RECORD DRAWINGS JULY 25, 2003
 THIS RECORD DOCUMENT HAS BEEN PREPARED BASED ON INFORMATION PROVIDED BY OTHERS. THE CONSULTANT HAS NOT VERIFIED THE ACCURACY AND/OR COMPLETENESS OF THIS INFORMATION AND SHALL NOT BE RESPONSIBLE FOR ANY ERRORS OR OMISSIONS THAT MAY BE INCORPORATED AS A RESULT OF ERRONEOUS INFORMATION PROVIDED BY OTHERS.

NO.	DATE	REVISIONS	APPROVED			
TRAFFIC CALMING DETAIL						
KENWAY DRIVE						
RIDGE VIEW ADDITION REHAB						
HUITT-ZOLLARS		<small>HUITT-ZOLLARS, Inc. 831 McKinney Avenue, Suite 600 Dallas, Texas 75204-2489 Phone (214) 871-3311 Fax (214) 871-0757</small>				
CITY OF ROCKWALL, TEXAS						
DESIGN	DRAWN	APPR.	SCALE	DATE	PROJECT NO.	NO.
HZI	HZI	KAR	1" = 10'	AUGUST 2002	01-3018-01	P-10

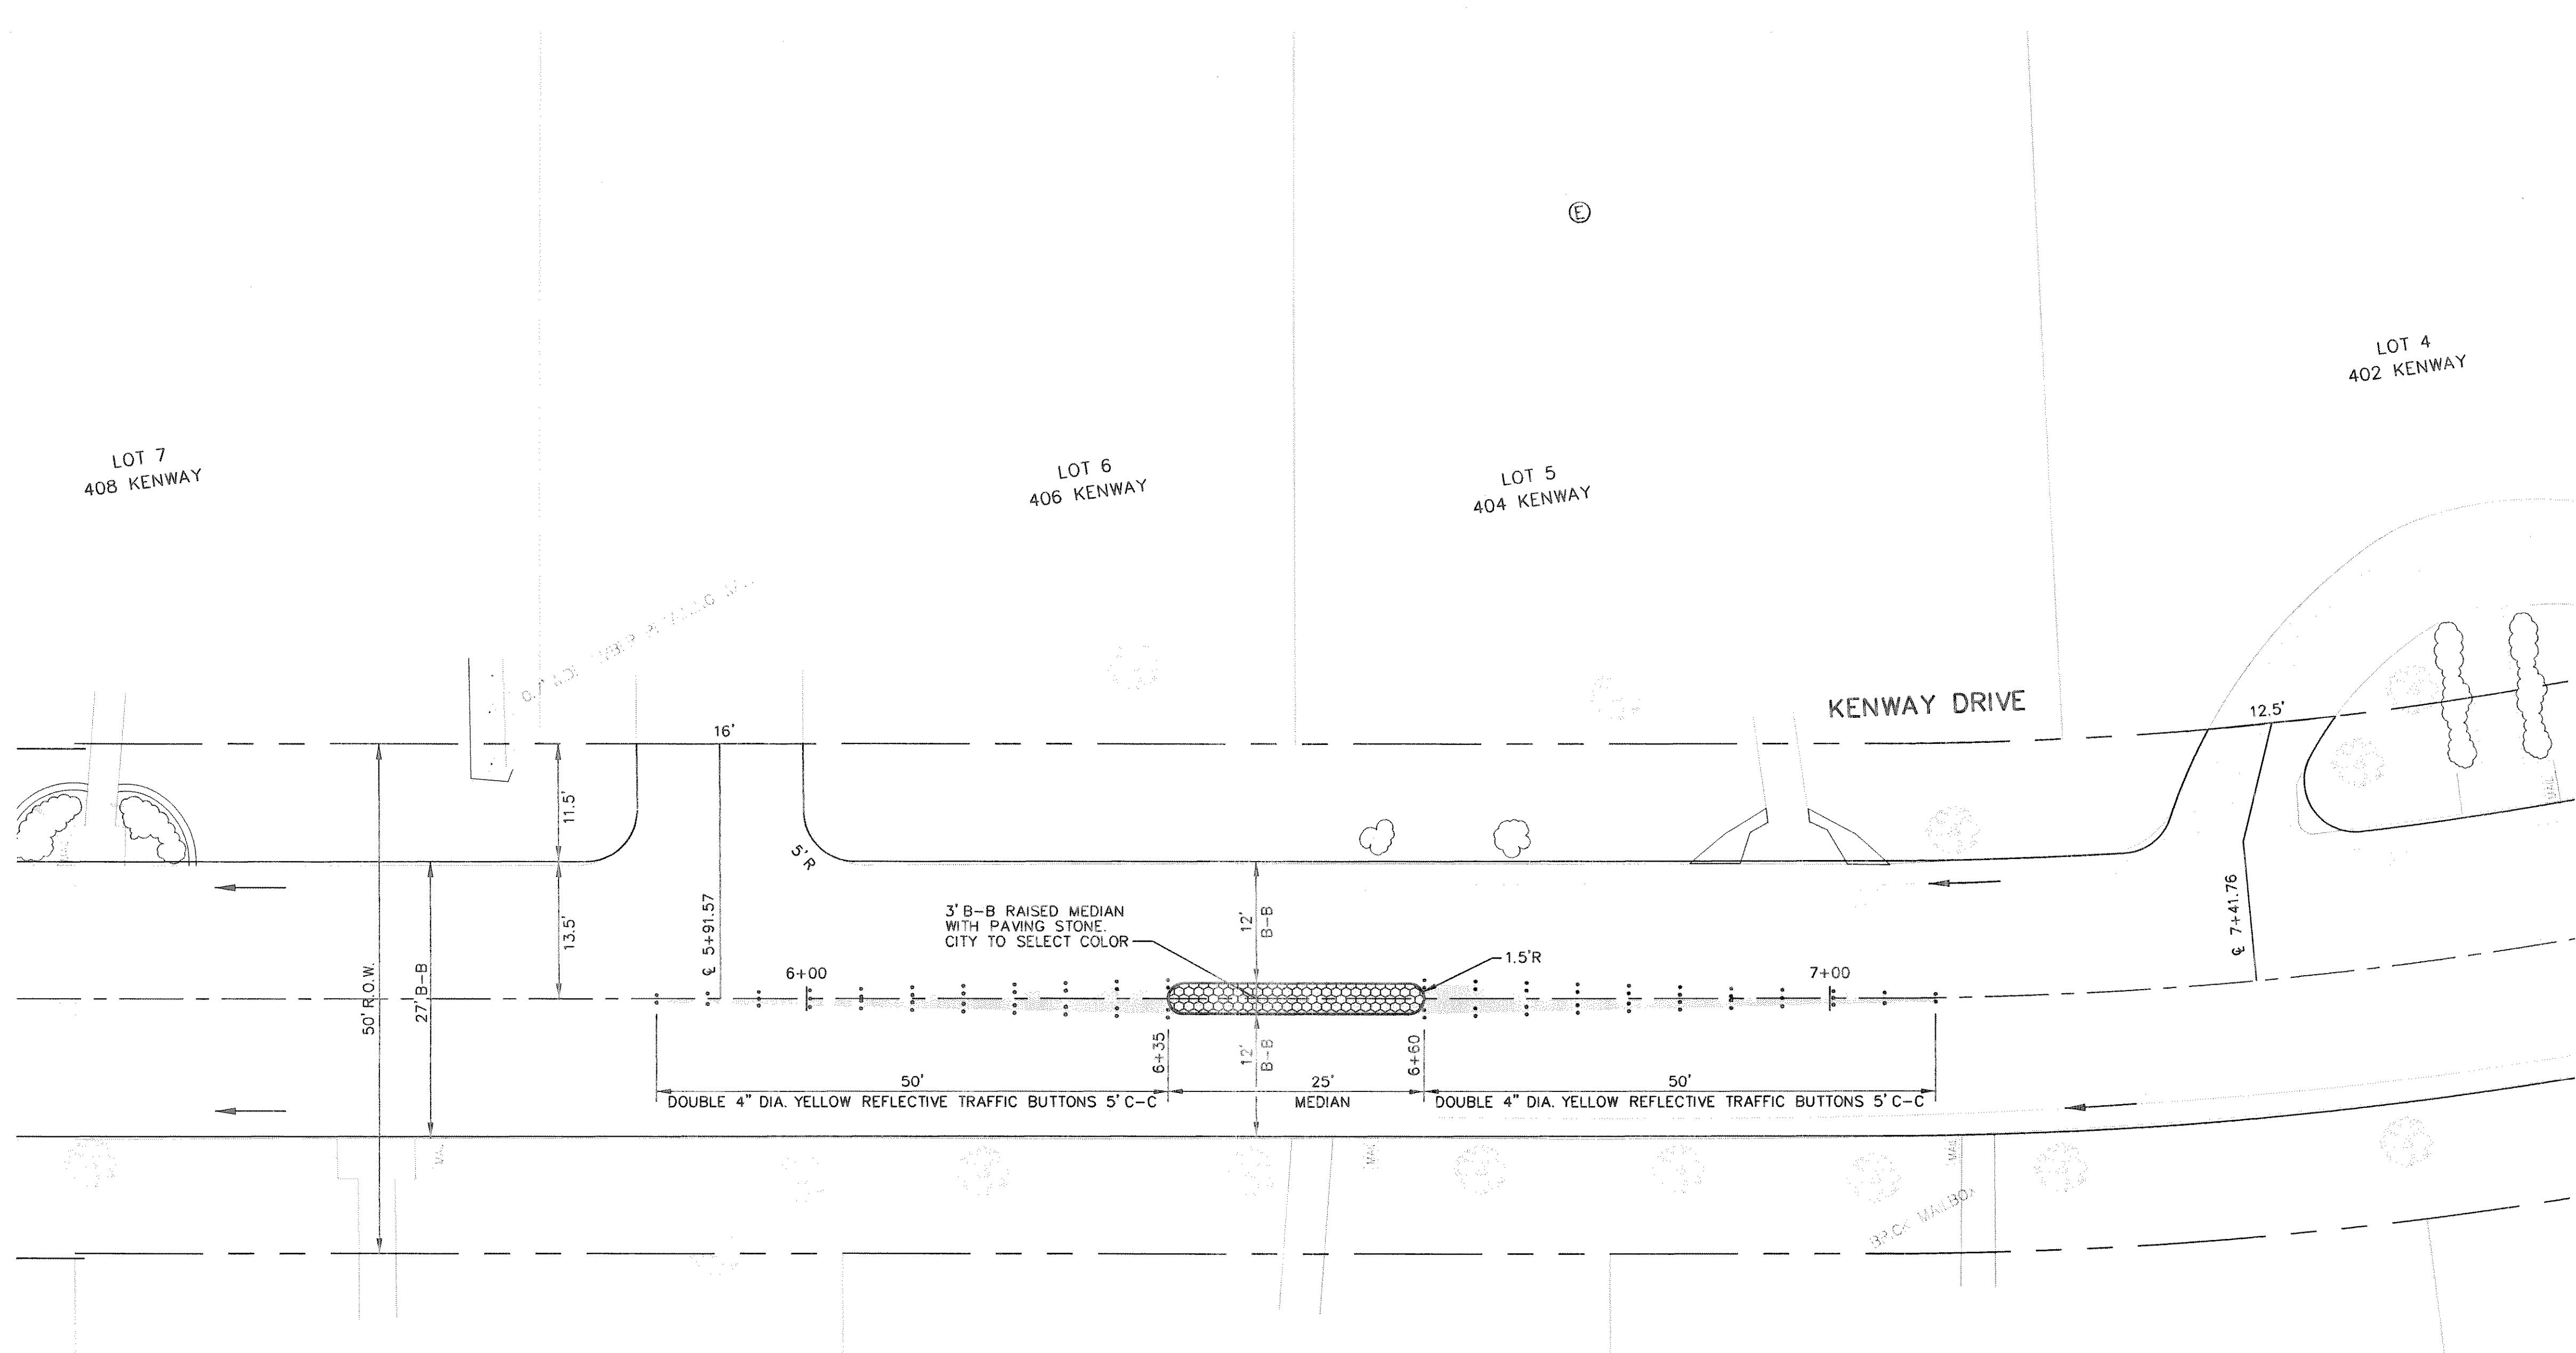
THIS WORK DELETED FROM THE CONTRACT
